## REVISED RESPONSE TO REQUEST FOR ADDITIONAL INFORMATION

### APR1400 Design Certification

Docket No. 52-046

**RAI No.:** 521-8696  
**SRP Section:** 07.06 – Interlock Systems Important to safety  
**Application Section:** 7.6.1.5  
**Date of RAI Issue:** 09/22/2016

Figure 7.6-3 Interlocks for CCW Supply and Return Header Isolation Valve

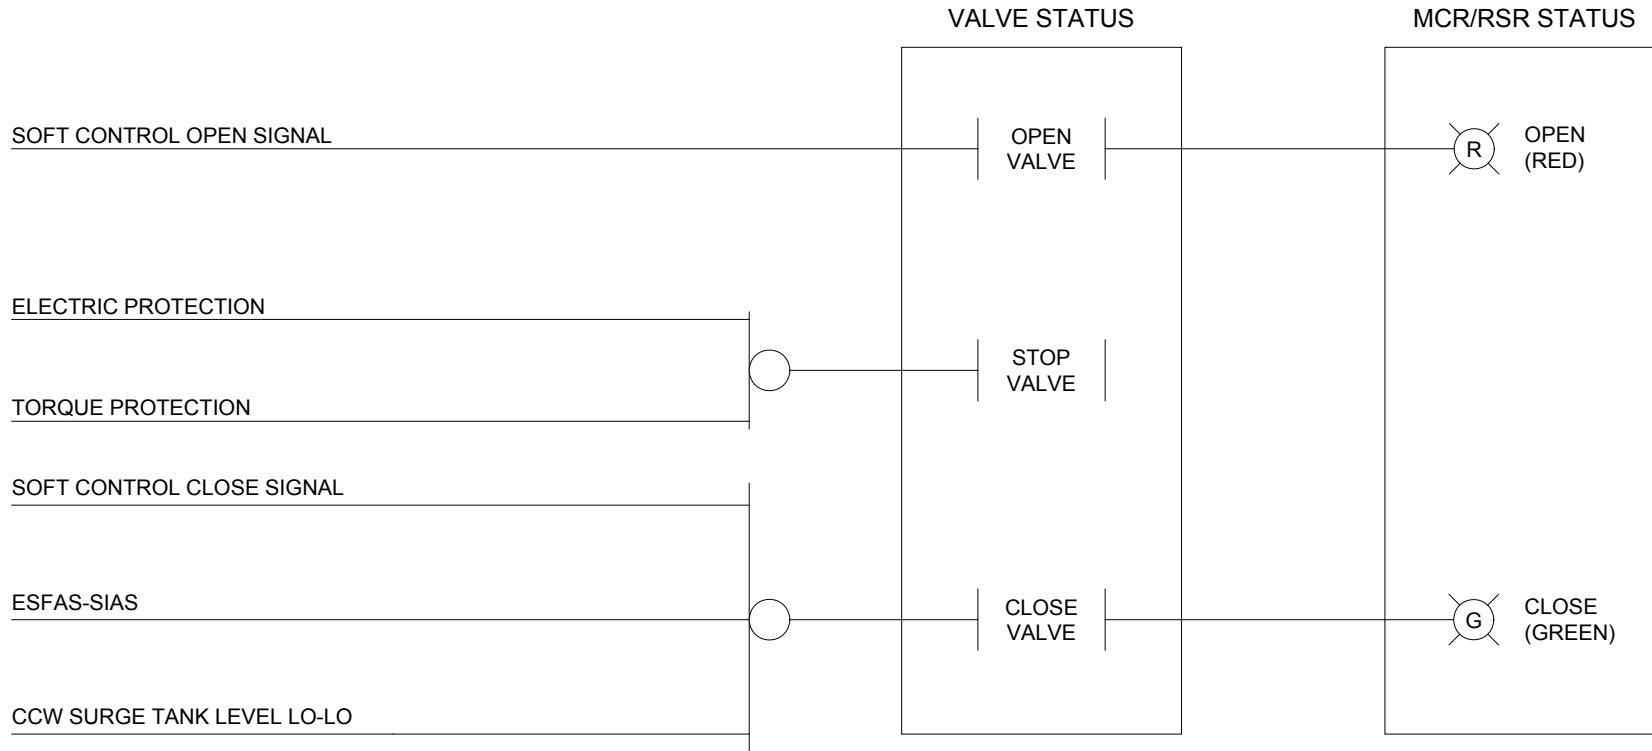
DCD descriptions disagree regarding the existence of Component Cooling Water (CCW) cross connections. NRC staff needs clarification in order to make a safety finding regarding system interlocks in the CCW system.

DCD Tier 2 Section 7.6.1.5, "Interlocks Required to Preclude Inadvertent Interties between Redundant or Diverse Safety Systems," states "...there is no connection between the CCW safety divisions, the APR1400 design does not include interlocks to prevent inadvertent interties between redundant or diverse safety systems." However, this statement conflicts with DCD Tier 2, Sections 9.2.2.2.2.4 (2nd paragraph) and 9.2.2.2.2.4.c, Figure 9.2.2-1, "Component Cooling Water System Flow Diagram," DCD Tier 1, Section 2.7.2.2.1, "Design Description," Table 2.7.2.2-2, "Component Cooling Water System Components List," and Figure 2.7.2.2-1, "Component Cooling Water System," which reflect cross connection supply and return values (CC-937, 938, 939, and 940) connecting the two CCW divisions and that these two valves in series automatically close on a Safety Injection Actuation Signal (SIAS) control signal from different divisions.

Clarify and update DCD Tier 1 and 2 to reflect whether there are cross-connections between the two divisions of CCW. If there are cross-connections, ensure that instrumentation and control system descriptions are appropriately corrected.

The statements in Section 7.6.1.5 that there is no connection between CCW safety divisions is not an accurate reflection of the current system design as specified in Tier 2 Section 9.2.2.2.2 and Tier 1 Section 2.7.2.2. There are two cross connections between the CCW divisions that are normally locked closed during operation through two in-series motor operated valves on each cross connection. If opened, the valves will close through interlocks with an SIAS or on a low-low surge tank level. These functions are tested in accordance with the pre-operational testing specified in Section 14.2.12.1.76.

The description of this CCW interlock function will be incorporated into DCD Tier 2 section 7.6.1.5, [with appropriate references to Figure 7.6-3 and Table 7.6-2 \(which will also be revised\)](#) to be consistent with the design and that which is described in other DCD sections. Except for CCW, there are no other systems that have automatic isolation controls between cross connected safety divisions.

DCD Tier 2, Subsections 7.6.1, 7.6.1.4, 7.6.1.5, [Table 7.6-2](#), and [Figure 7.6-3](#) will be revised as shown in the attachment.

Interlocks for CCW non-essential supply and return header isolation valves and cross connection line isolation valves.
